## First Revision No. 18-NFPA 211-2014 [ Detail ]

**First Revision No. 1-NFPA 211-2014 [ Section No. 2.3.1 ]****2.3.1 ASHRAE Publications.**

**First Revision No. 16-NFPA 211-2014 [ Section No. 7.1.2 ]**

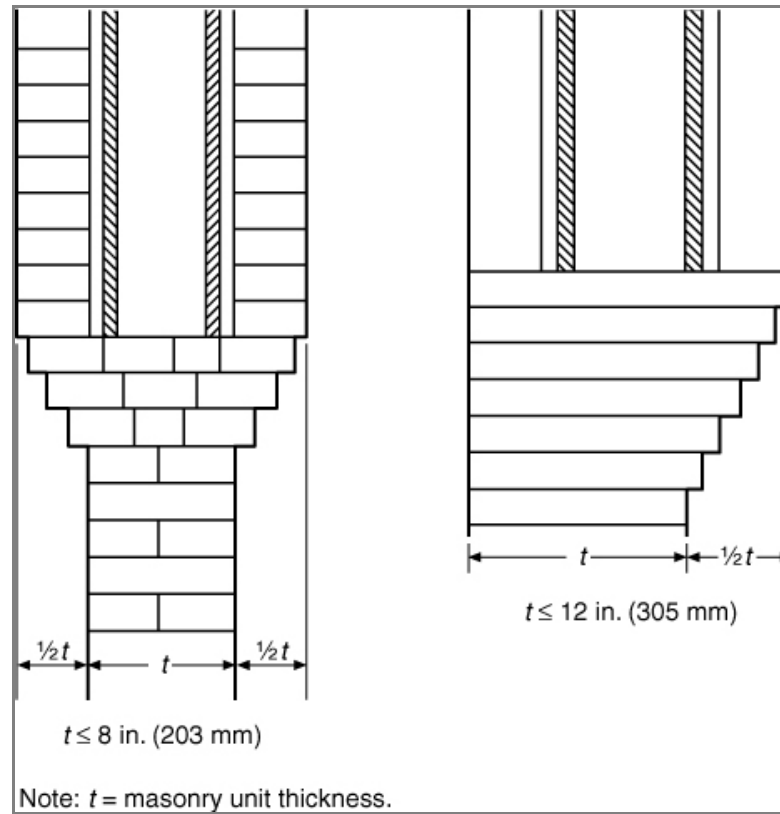
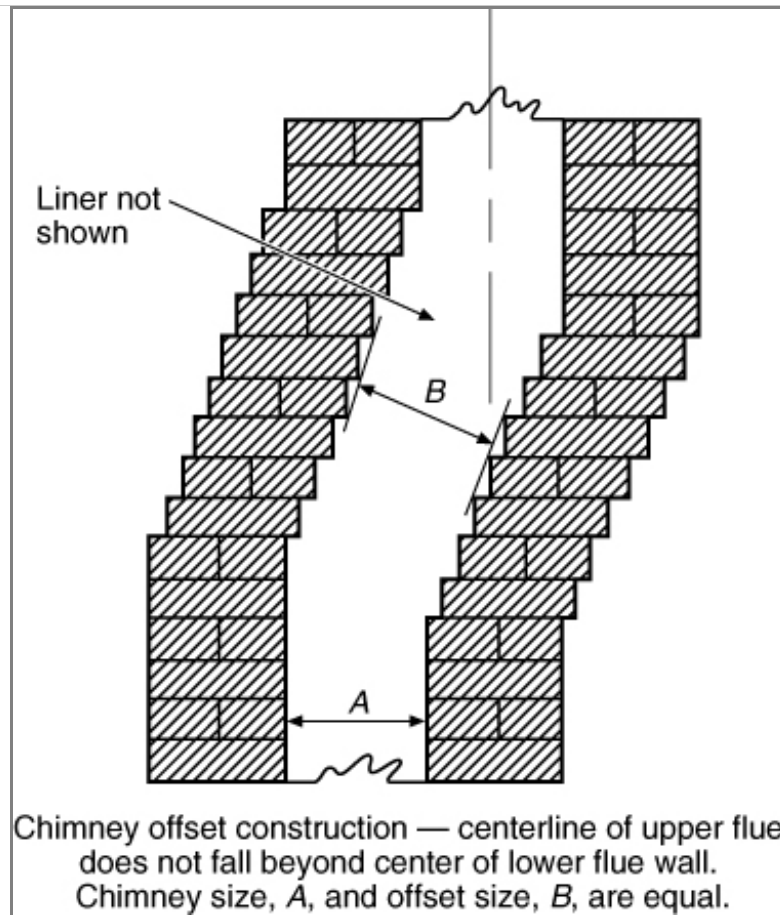
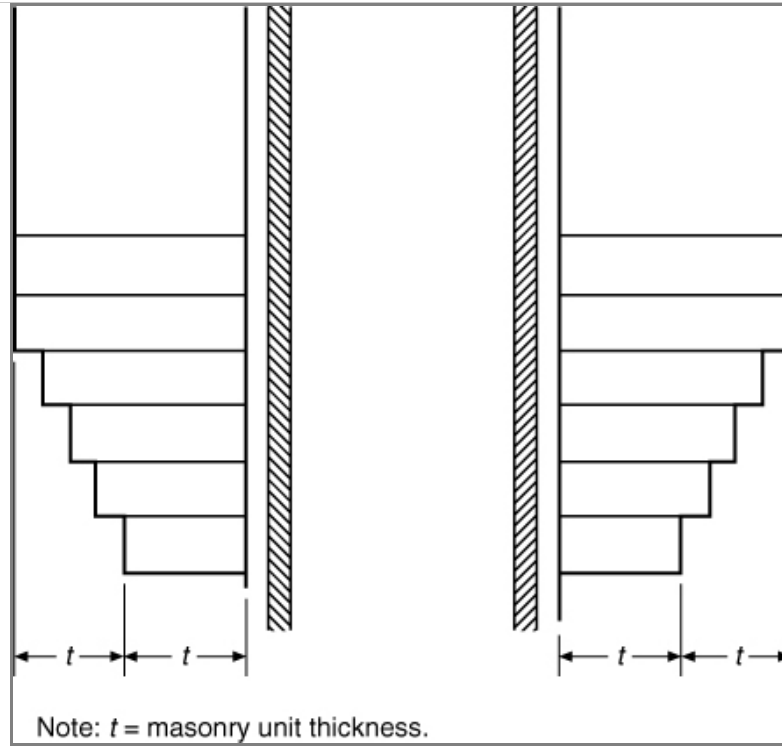
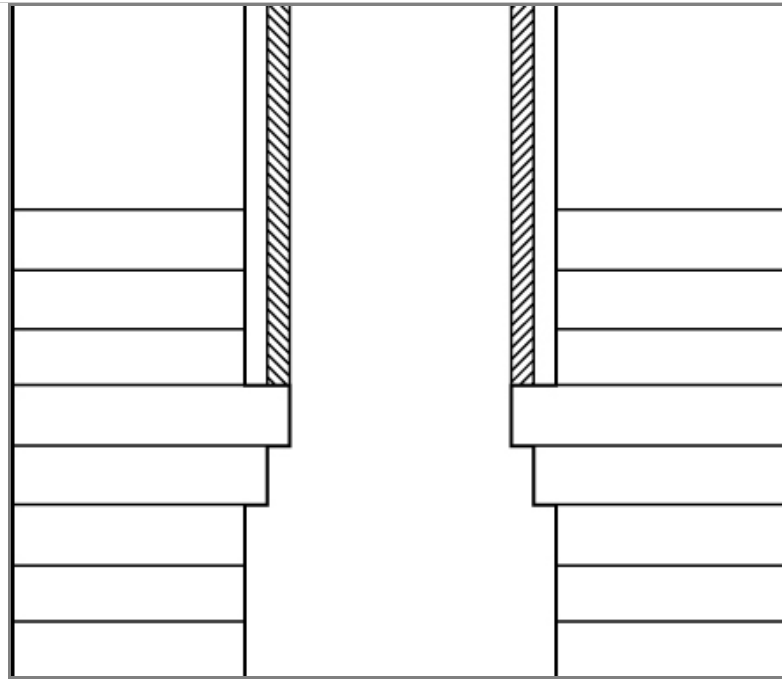
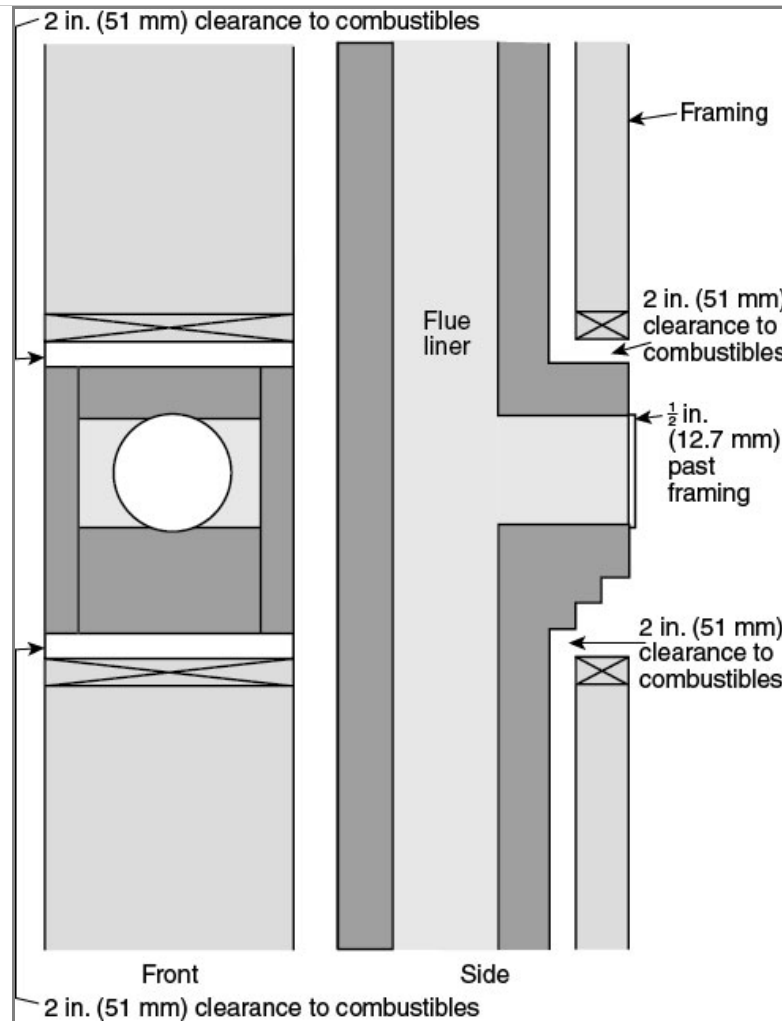
Individual and maximum projections of corbels in masonry chimneys shall comply with the requirements of this section. [See [Figure 7.1.2\(a\)](#) through [Figure 7.1.2\(e\)](#) ~~Figure 7.1.2(d)~~ .]

**Committee Statement:** A new figure is added to provide guidance for using masonry construction to incorporate a wall pass-through in the chimney construction.

Corbeling used to incorporate wall pass-through shall be constructed in accordance with [7.1.2](#) and [Figure 7.1.2\(e\)](#) .

**Figure B.2 Chimney Connector Systems and Clearances from Combustible Walls for Residential Heating Appliances.**

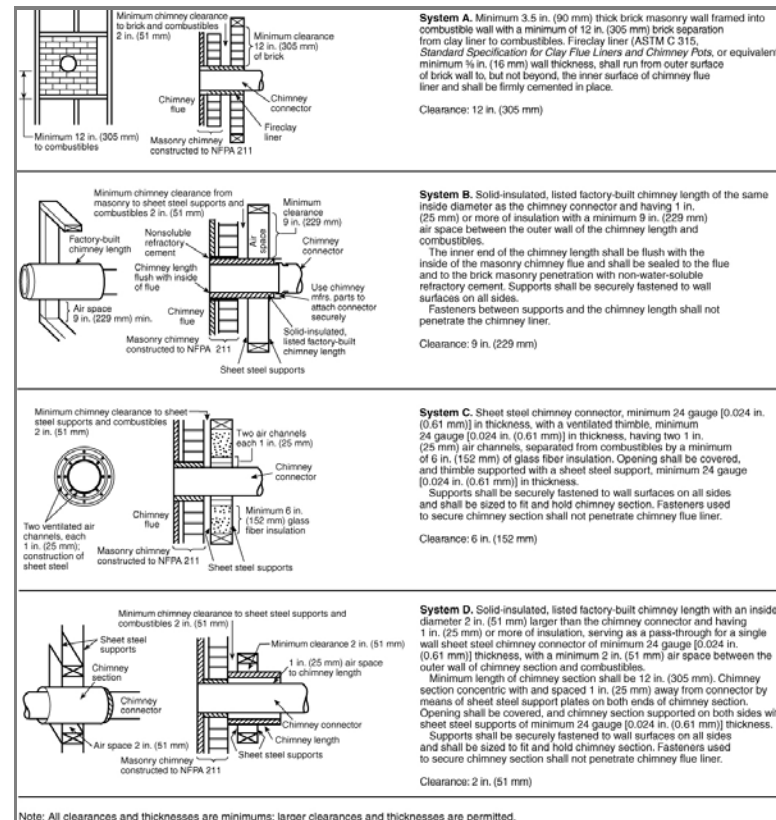
**Committee Statement:** The result of the First Revision is to relocate subsection 9.7.5 to a new Annex B as shown on the attached. At the time the systems shown in Figure 9.7.5 were added to NFPA 211, listed wall pass-through were not commercially available. However, listed wall-pass through systems are now readily available. Therefore, field-constructed wall pass-through systems are no longer permitted for new construction. The field-constructed systems are susceptible to human error in construction and installation. In addition, these systems can be subject to long-term deterioration due to moisture issues and structural movement. However, the committee recognizes that this information should be maintained for inspecting or evaluating existing installations.

**Figure B.2. ~~9.7.5~~ Chimney Connector Systems and Clearances from Combustible Walls for Residential Heating Appliances.**
